PRECISION TIME SYSTEMS

Generation 6 Platform — Introduction and Instructions

To: NBA Game Operations Staff
From: Steve Truckenbrod, Precision Time Systems
Re: Introduction to the Generation 6 Precision Time Platform

Brighter touchscreen, raised light bar and internal antenna

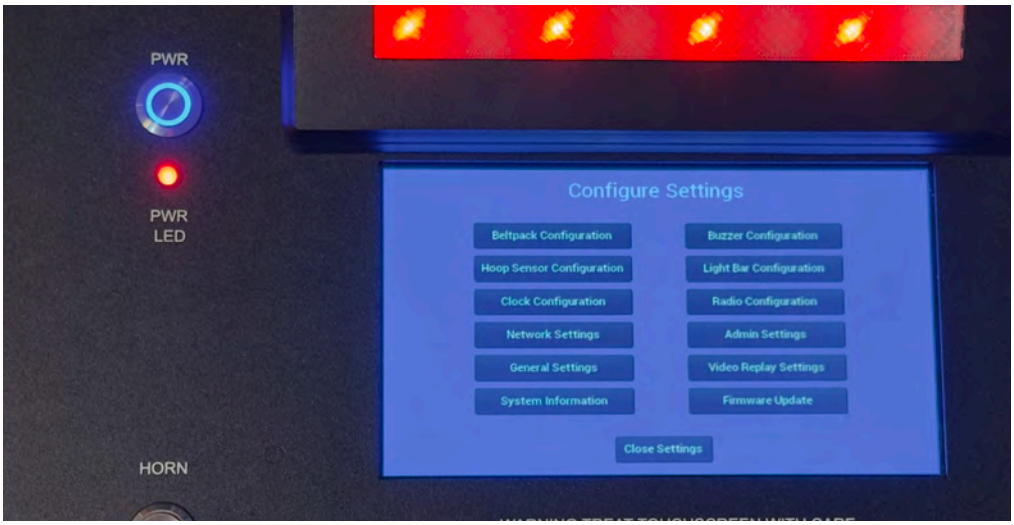
- Brighter, more visible touchscreen — enhanced display for improved readability under all lighting conditions.

- Raised light bar with adjustable settings — provides better at-a-glance visibility from a distance, with the ability to adjust brightness as needed.

- Internal antenna located within the light bar — repositioning the antenna internally reduces the risk of physical damage during transport and setup.

Adjustable rear feat and unchanged scoreboard connections

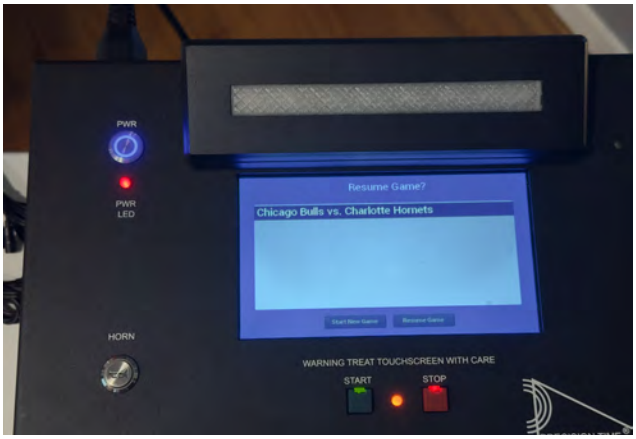
- Adjustable rear feet — allow the base station to be angled for optimal viewing of the touchscreen from the timekeeper's position.

Resume Game or Start New Game Options

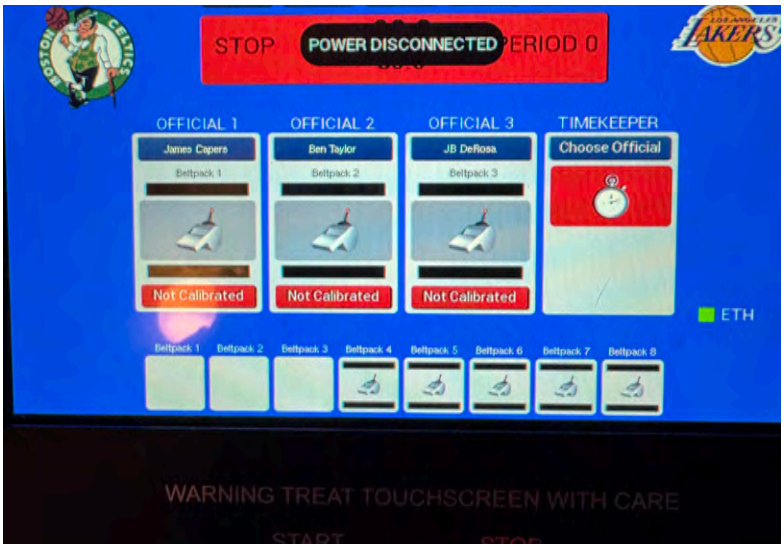
- Significantly reduced boot-up times — the system reaches operational readiness exponentially faster than previous generations, usually with 12 seconds.
- Resume Game option — if the base station needs to be reset or rebooted during a game, operators can now resume the game in progress rather than starting from scratch.

Internal Battery Warning Indicator, disappears when power is re-enabled

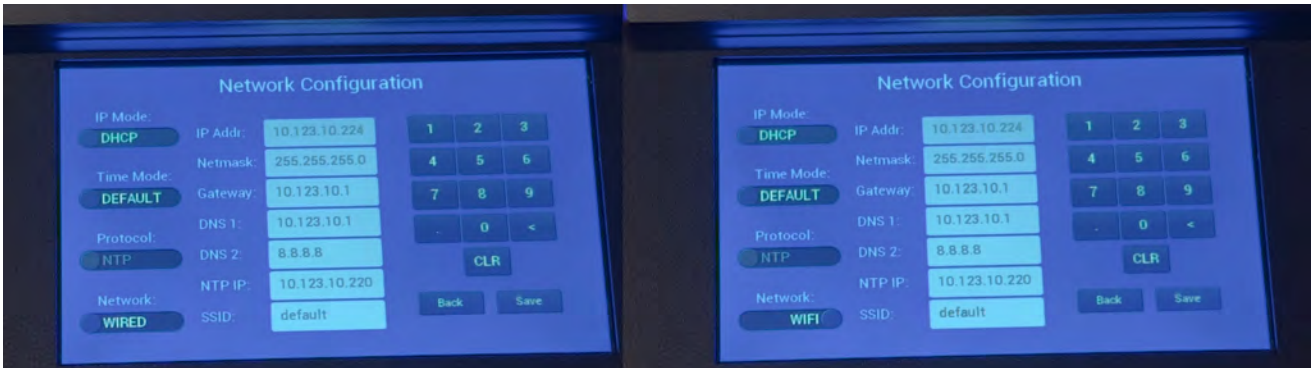
- Internal battery warning indicator — the system will display a visible alert if the base station is running on its internal backup battery, prompting staff to verify that the unit is properly connected to primary power.

Live Clock Video

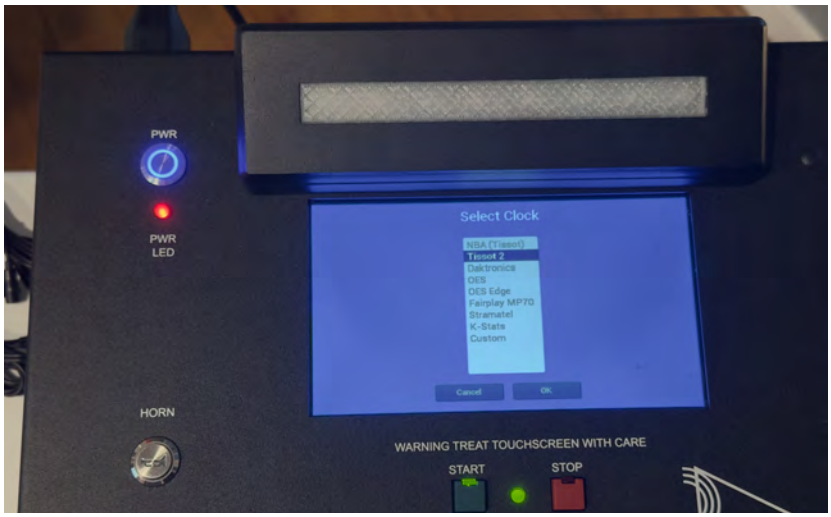
- A live clock on the home screen — the Generation 6 replaces the “stopped clock time” with a synchronized game clock to provide “real time” game clock status for timekeepers.

Tap, Add, Enter Timekeeper Manually

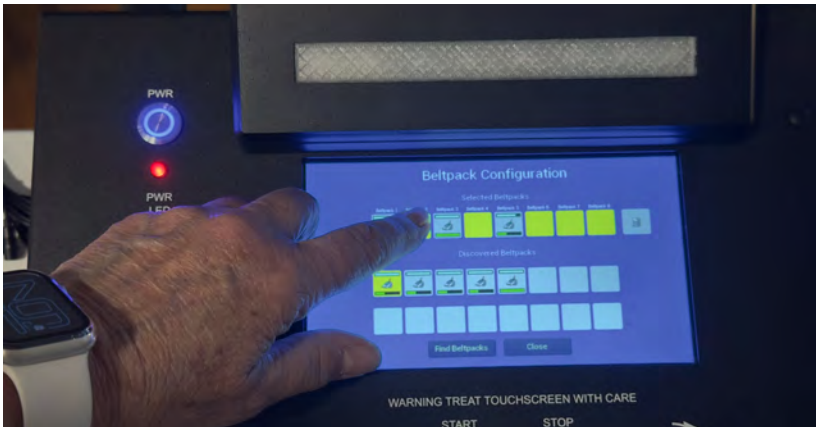
- Whistle settings — whistle sensitivity settings remain accessible within each assigned referee window, consistent with the Generation 5 interface.
- Timekeeper entry — timekeepers must now be entered and selected manually. The system no longer uploads timekeeper assignments automatically.
